NATIONAL BOARD INSPECTION CODE SUBGROUP INSTALLATION

AGENDA

Meeting of January 14, 2025 Charleston, SC

FIGURE S3.6.1-b

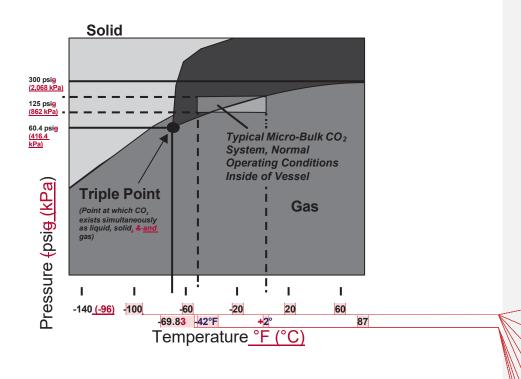
Explanation of Need: In accordance with the NBIC Policy For Metrication, metric units need to be shown alongside US customary units. Table S3.6.1 and Figure S3.6.1-b both show only US customary units. I recommend adding a Table S3.6.1M and Figure S3.6.1-bM to show metric units. I've also included some additional editorial recommendations.

Commented [MV1]: Note: the comments below are the equivalent Celsius temperatures to add next to or below the Fahrenheit temps

Commented [MV10]: 30

Commented [MV2]: Add -(73) to this

Commented [MV3]: -51

Commented [MV4]: -29

Commented [MV5]: -7

Commented [MV6]: 16

Commented [MV7]: 56.6

Commented [MV8]: -41

Commented [MV9]: 7
